Huntlee New Town (Stage 1) Mod 10

Section 4.55(1A)
Modification Assessment
(MP 10_0137 MOD 10)

May 2019

Figure 4 | Proposed modifications under Mod 10

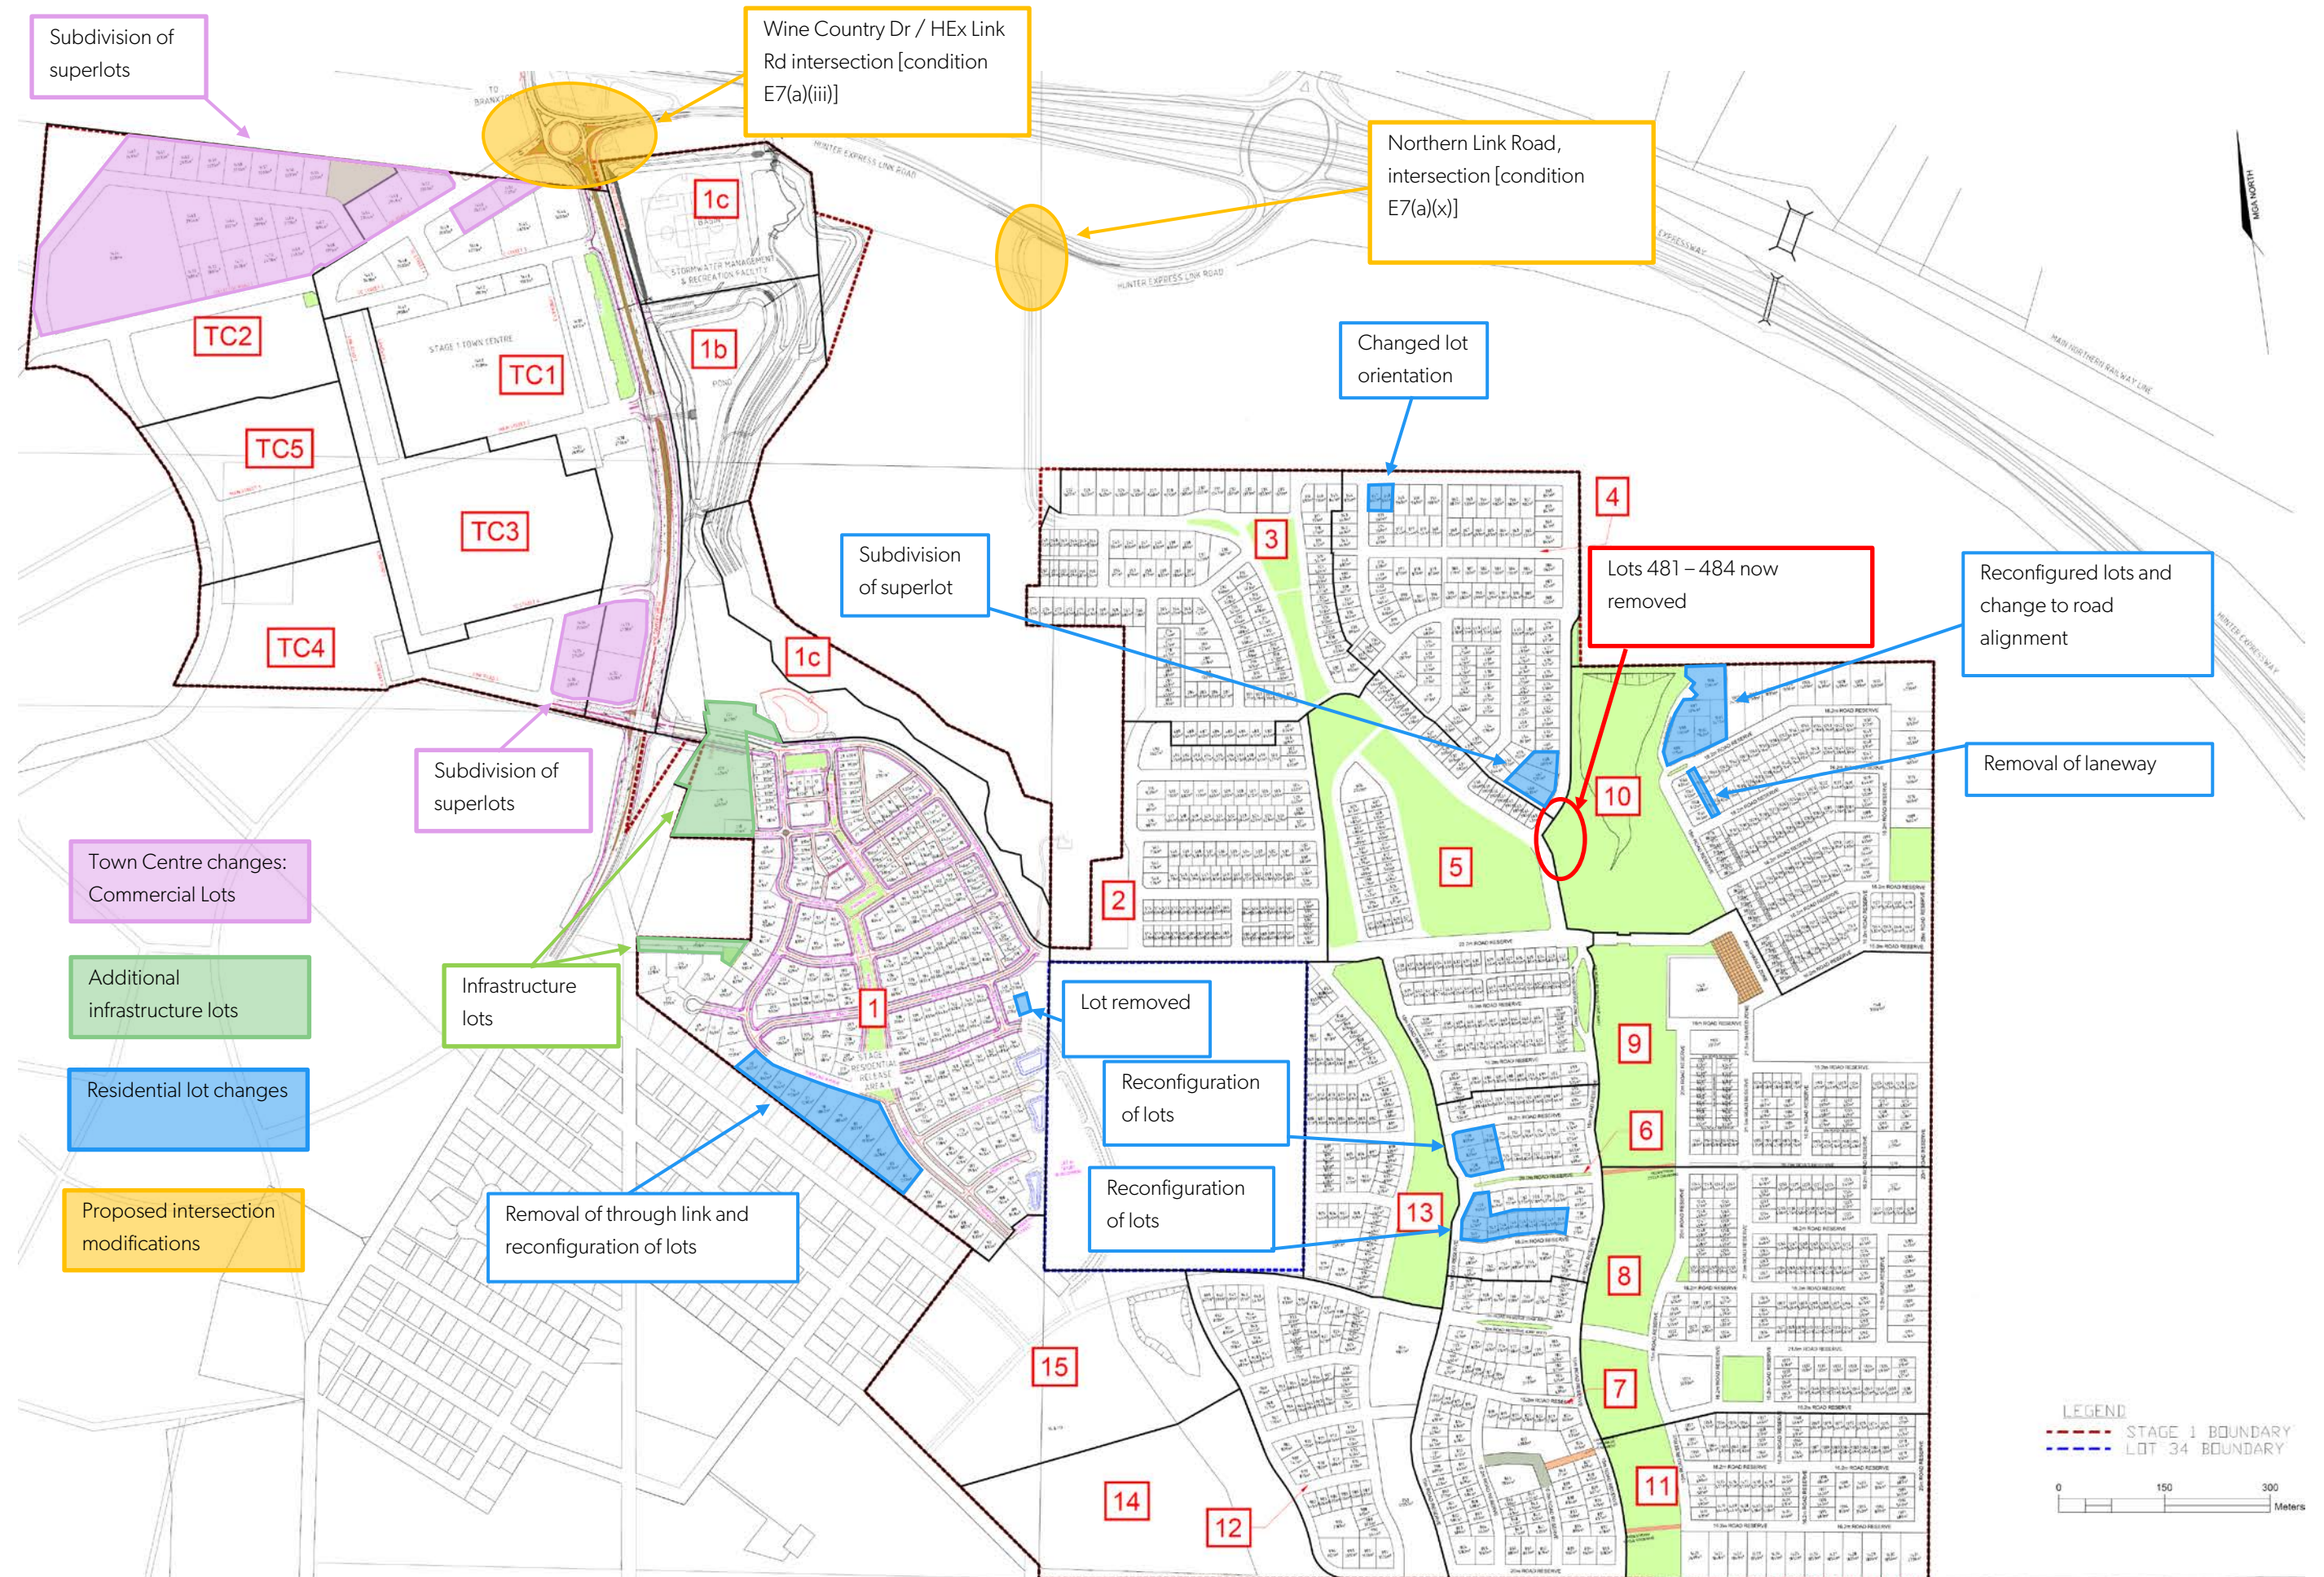
Removal of link in Precinct 1 and laneway in Precinct 10

- The proposal seeks to remove a connecting link between Precinct 1 and the North Rothbury subdivision to the south (see figure 4).
- The Department considers the removal of the link in Precinct 1 through to the North Rothbury subdivision is acceptable given there is another similar link in close proximity to the southeast.

Further, the connecting link in the North Rothbury side is in private ownership, zoned R2 and is of a developable area. Therefore, this land can be developed for residential purposes, resulting in a reduced likelihood of the accessway being delivered. The other remaining access however is adjacent to Council owned land and is a more desirable option to provide a connection to the existing North Rothbury subdivision.

The Department also notes Council and RFS raised no concerns regarding the removal of the link.
- The proposal also seeks approval to remove a laneway in precinct 10 (see figure 4). The removal of the laneway is supported in this instance because appropriate access to these lots can be gained from the street and it would not result in any significant traffic impacts as the lots front a low volume street. Further, the Department is satisfied that the width of the lots is sufficient to accommodate a dwelling with a garage facing the street, without resulting in significant visual impacts.
- The Department therefore considers the removal of the link in Precinct 1 and the laneway in precinct 10 is acceptable.

- No additional conditions or amendments necessary
